ADDENDUM 2 TO ENVIRONMENTAL IMPACT REPORT

Date of Publication of Addendum: March 4, 2026
Date of EIR Certification: June 15, 2017
Case No. **2024-005509ENV**
Project Title: **One Oak Street Project (1500-1540 Market Street)**
Block/Lot: 0836/001, 002, 003, 004, and 005
Project Sponsor: Brynn McKiernan, Emerald Fund, Inc.
(415) 489-1306
Lead Agency: San Francisco Planning Department
Staff Contact: Rachel Schuett – (628) 652-7546
rachel.schuett@sfgov.org

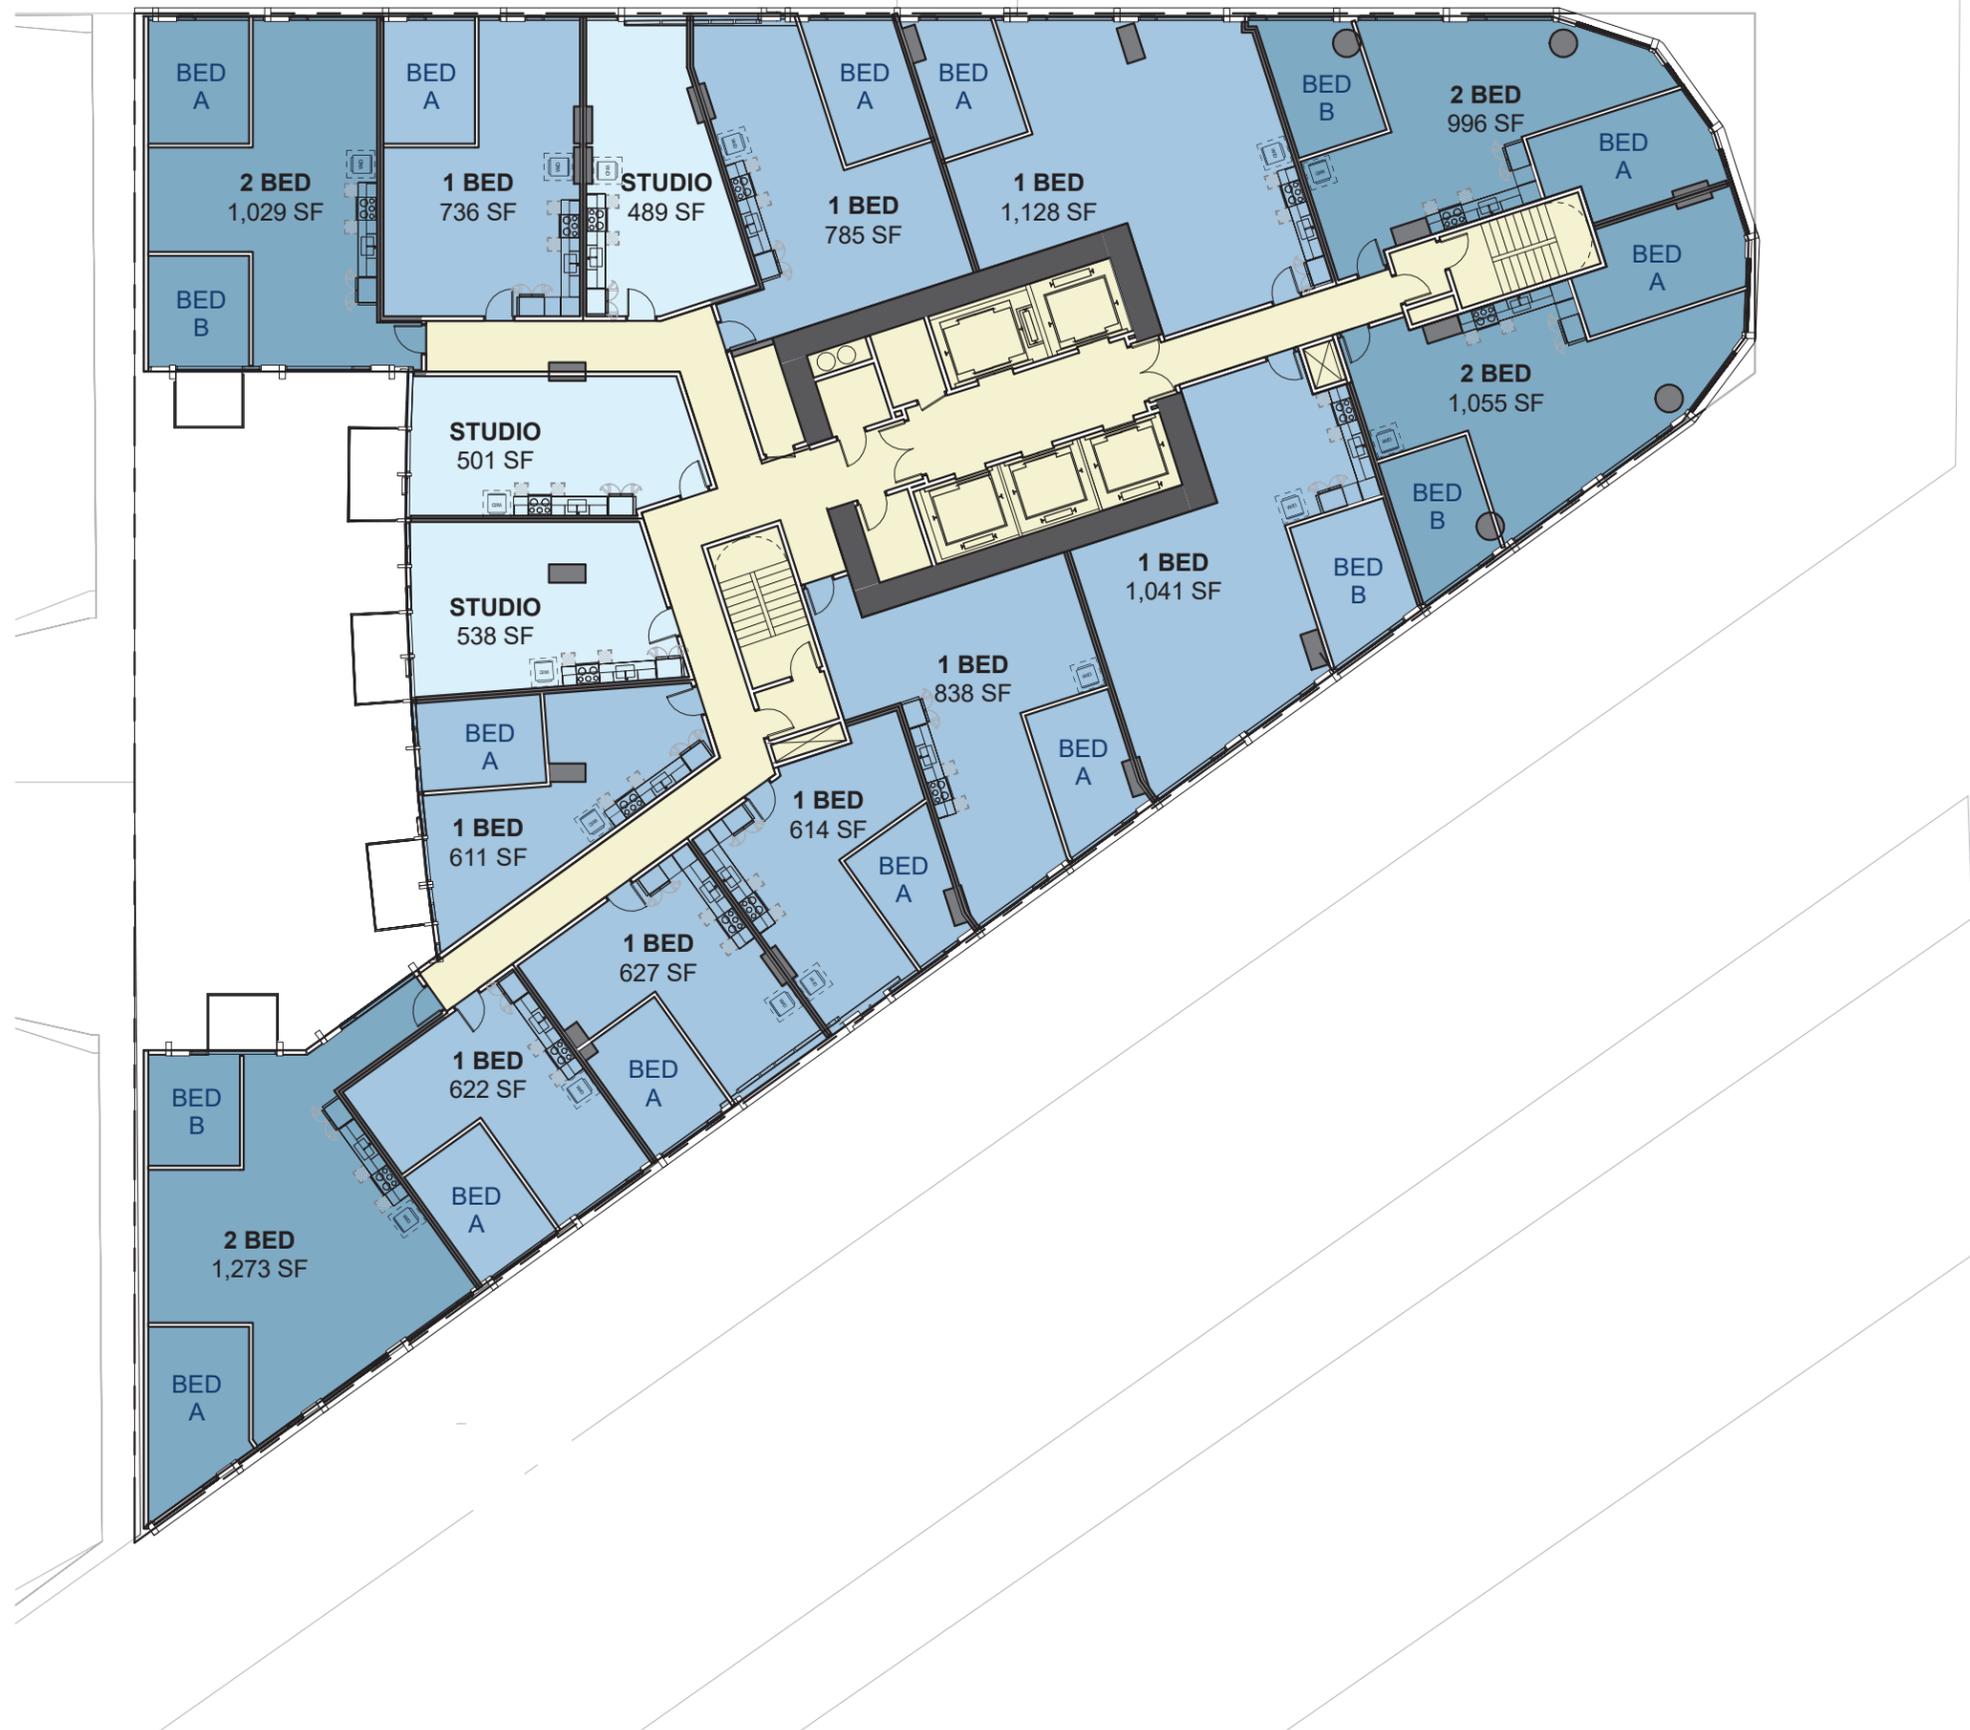
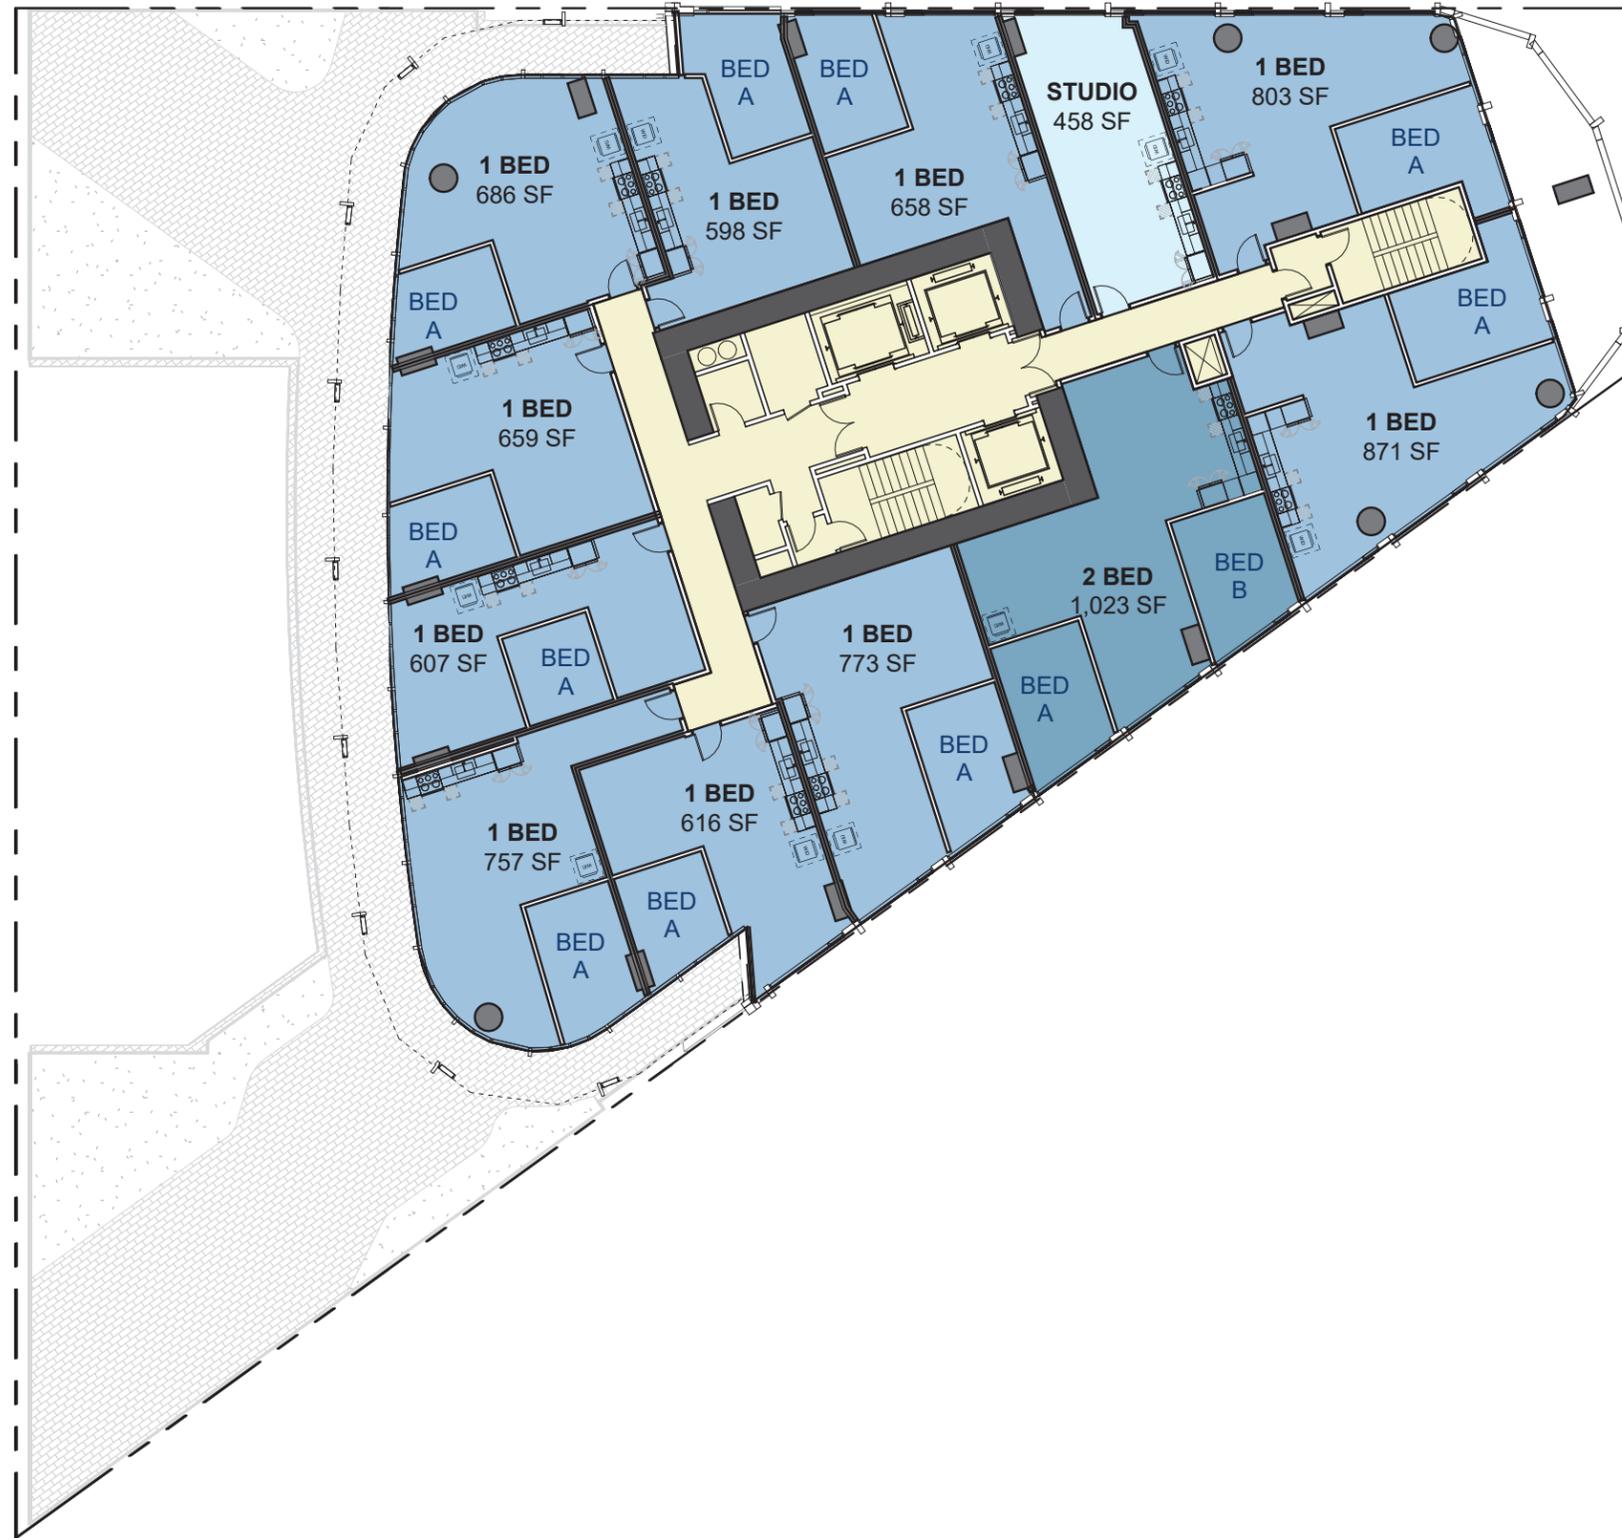
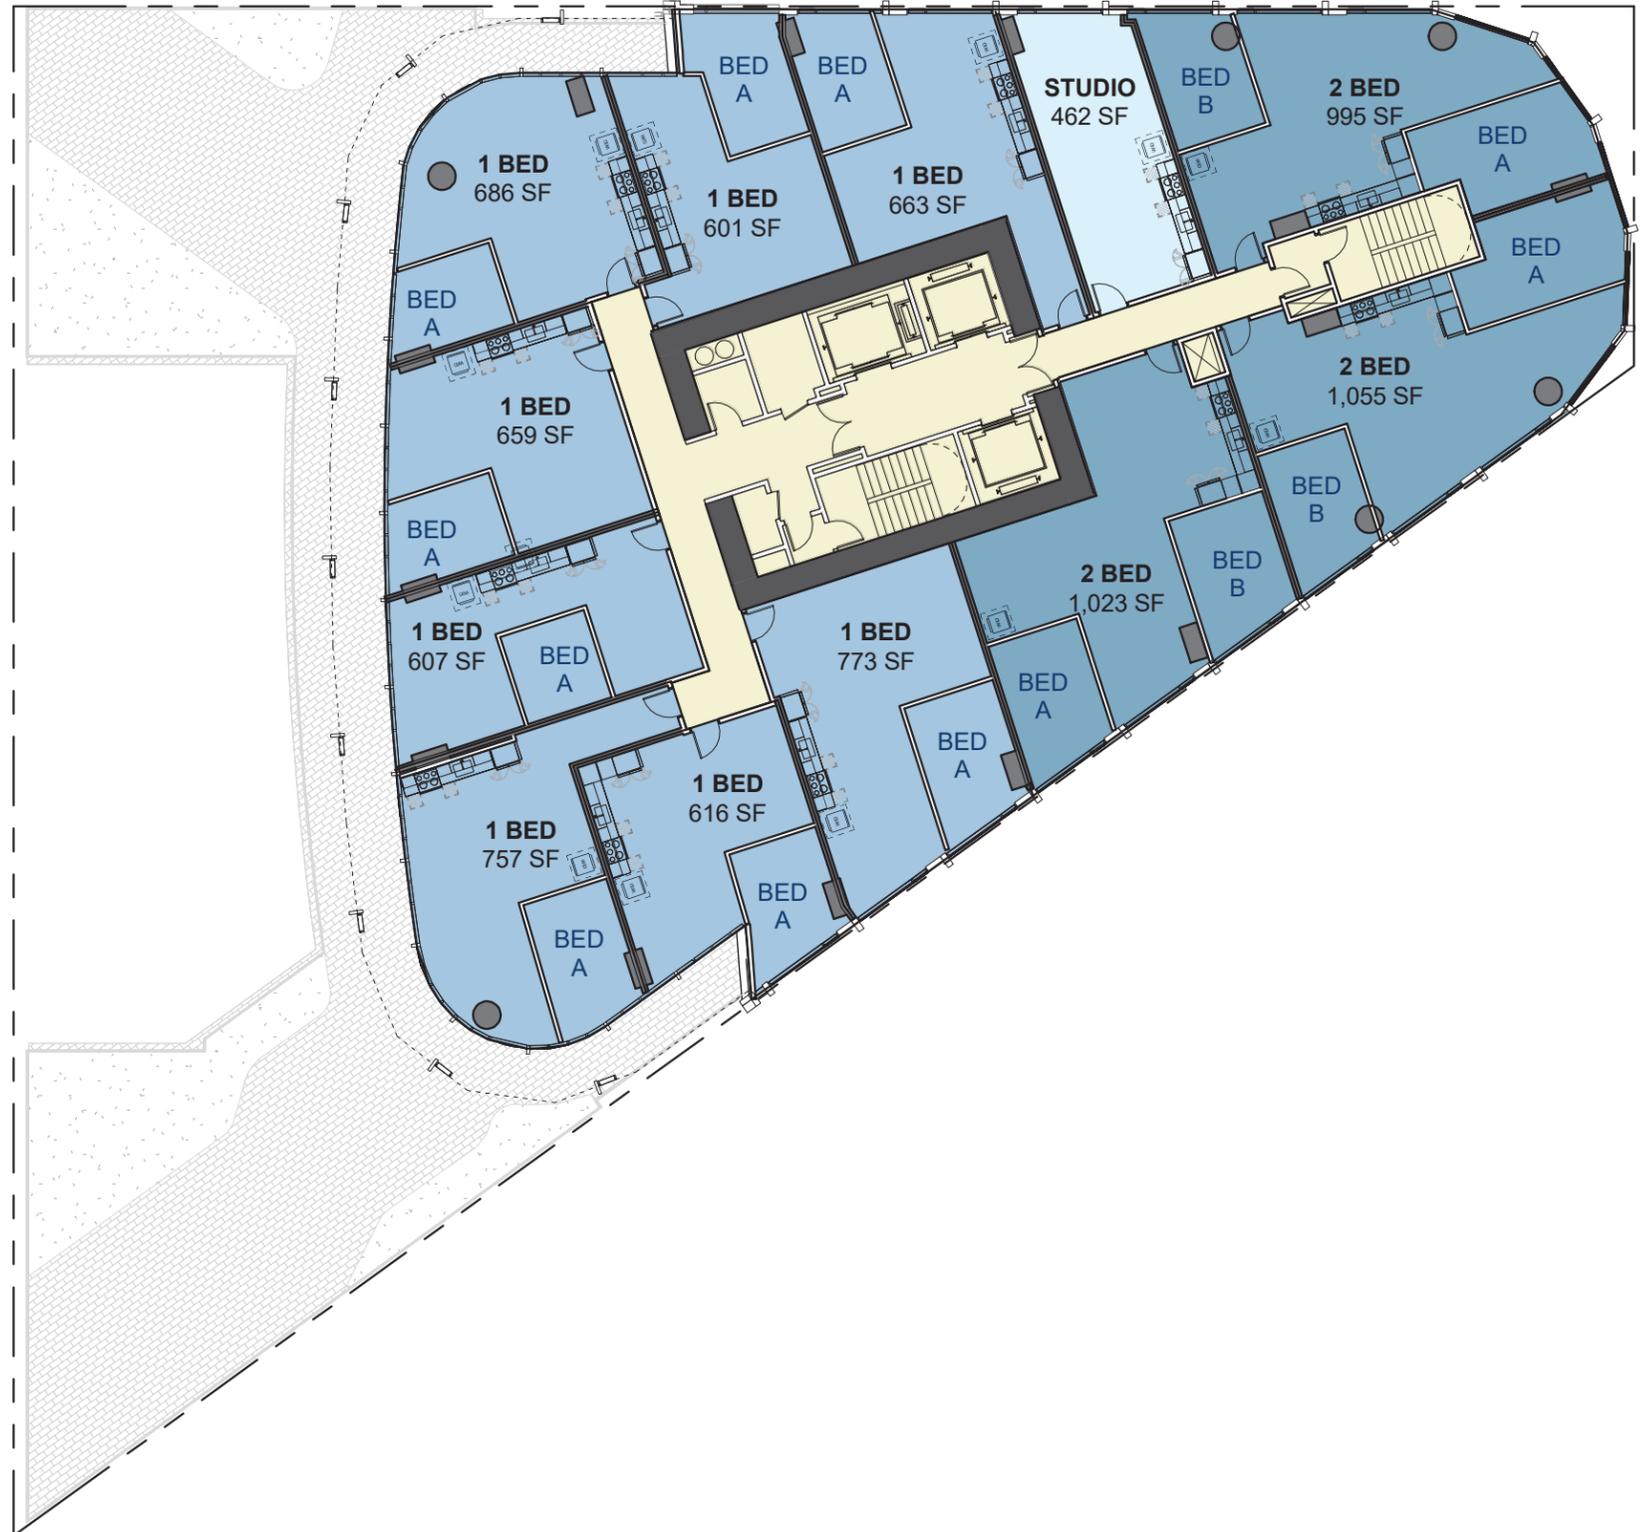
As shown in **Attachment A. Figures**, pp. 24, 39, 44 and 45, the revised project would incorporate the following wind-reducing design features:

INTEGRATED POROUS WIND CANOPY @ 25'-8" ABOVE GRADE. 12' DEEP ALONG OAK STREET AND MARKET STREET, 15' DEEP AT BUILDING'S NOSE
